VIRGINIA ELECTRIC AND POWER COMPANY
RICHMOND, VIRGINIA 23261

Serial No. 00-552
SPS/CGL-SLW R0"
Docket Nos. 50-280
50-281
License Nos. DPR-32
DPR-37

VIRGINIA ELECTRIC AND POWER COMPANY
SURRY POWER STATION UNITS 1 AND 2
RESPONSE TO REQUEST FOR ADDITIONAL INFORMATION,
REVISED PROPOSED TECHNICAL SPECIFICATION CHANGE AND
GL 99-02 RESPONSE CLARIFICATION ON
LABORATORY TESTING OF NUCLEAR-GRADE ACTIVATED CHARCOAL

RESPONSES TO NRC REQUEST FOR ADDITIONAL INFORMATION
GL 99-02 CHARCOAL FILTER TESTING FOR SURRY POWER STATION

Figure 47.1-3
Primary Ventilation
12.21.98

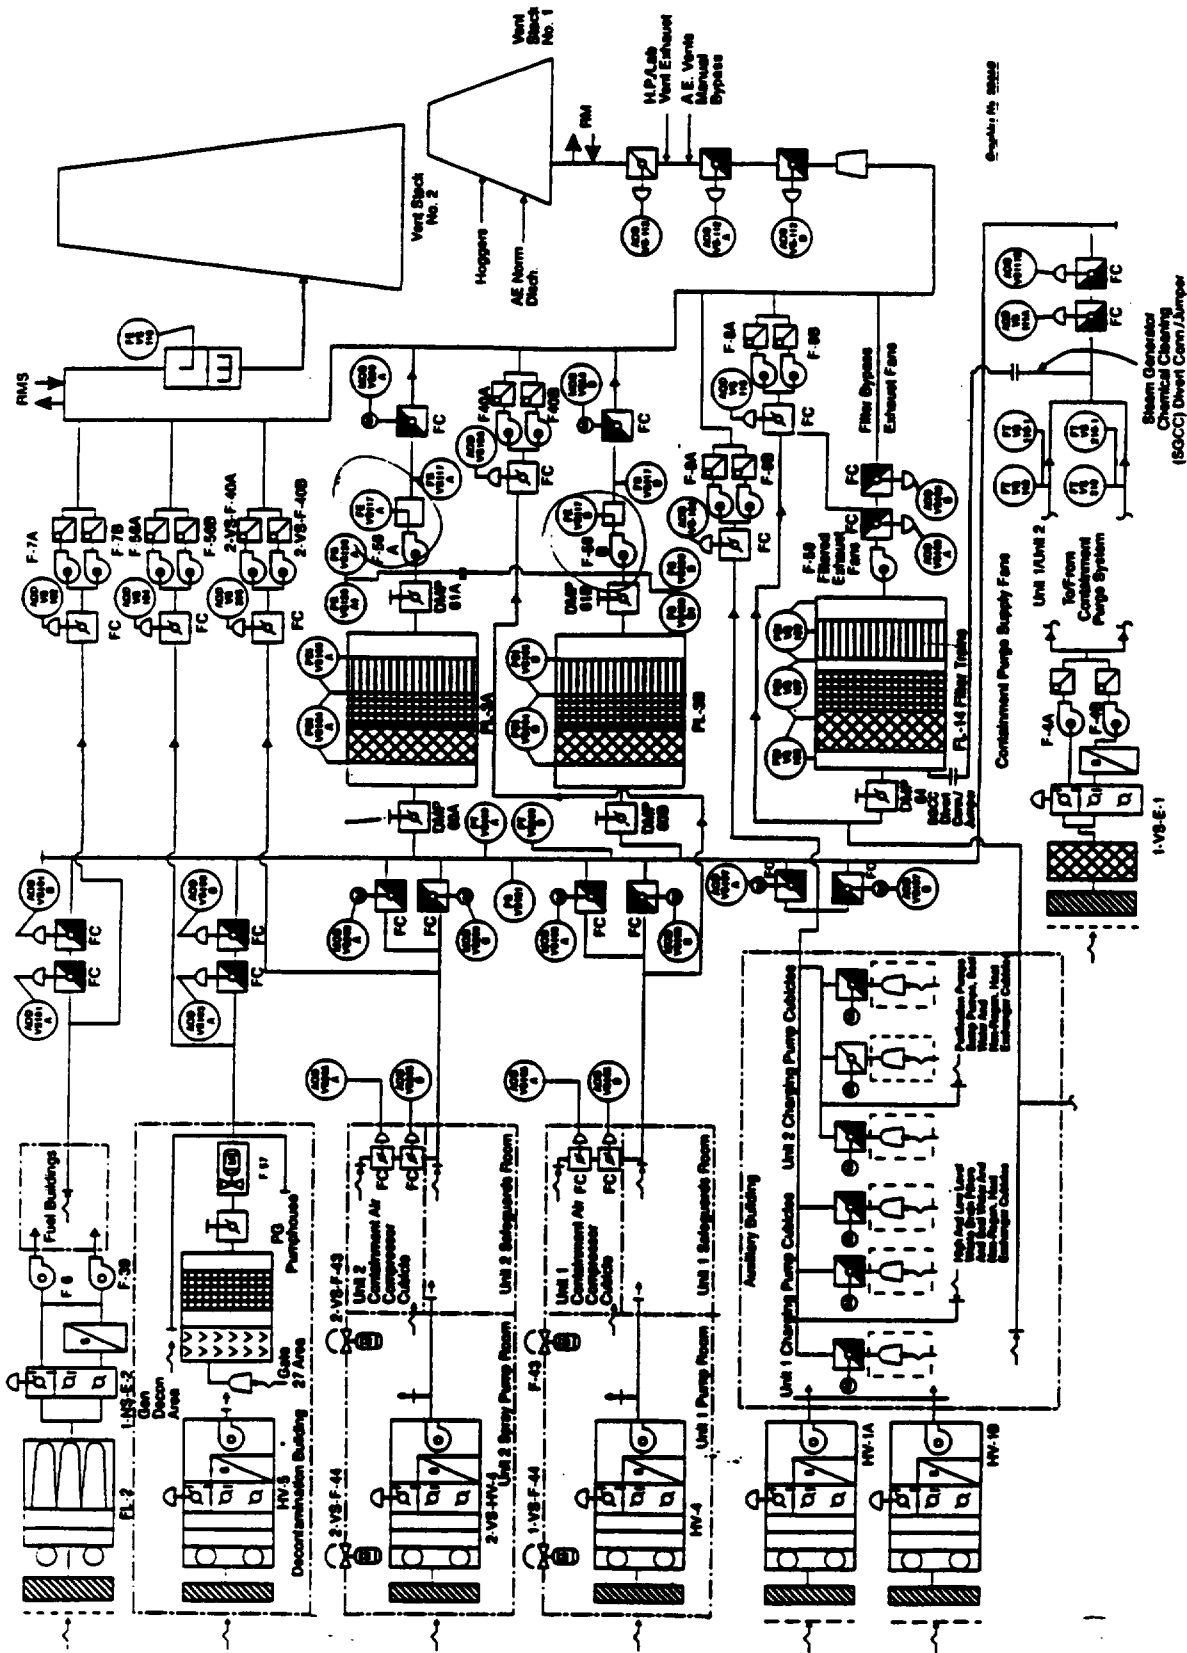
Your amendment request proposes to revise TS 4.12.A.6.c, 4.12.A.7.c and 4.12.A.8.c to specify “during system operation.” This is contrary to the staff position provided in a September 11, 1997 letter to Entergy, Inc. This letter stated that the “staff considers that a painting, fire, or chemical release is not in communication with the ventilation system only if it is not in operation and its isolation dampers are closed and leak tight thereby preventing air from passing through the filters.”

Specifying “during system operation” ignores the idea that the isolation dampers are closed and leak tight. Please provide your basis for why the term “during system operation” should be added to these three specs.

Application of the TS requirements for the Auxiliary Ventilation System is appropriate only “during system operation” based on the system design, configuration, and modes of operation. The Auxiliary Ventilation System layout is shown in the attached figure (page 7 of 7). The system is only operated during accident conditions or as required to filter the exhaust air from selected areas. In these alignments, the associated dampers are open and air is drawn through the filter bank, otherwise the isolation dampers to the filter bank and the filter bank exhaust fan are closed preventing air being drawn across the filter bank. In the isolated configuration, if any leakage through the dampers would occur, the air flow in the auxiliary building is such that communication with the filter banks would not occur. Therefore, the only time there will be flow across the filters is when the Auxiliary Ventilation System is operating.
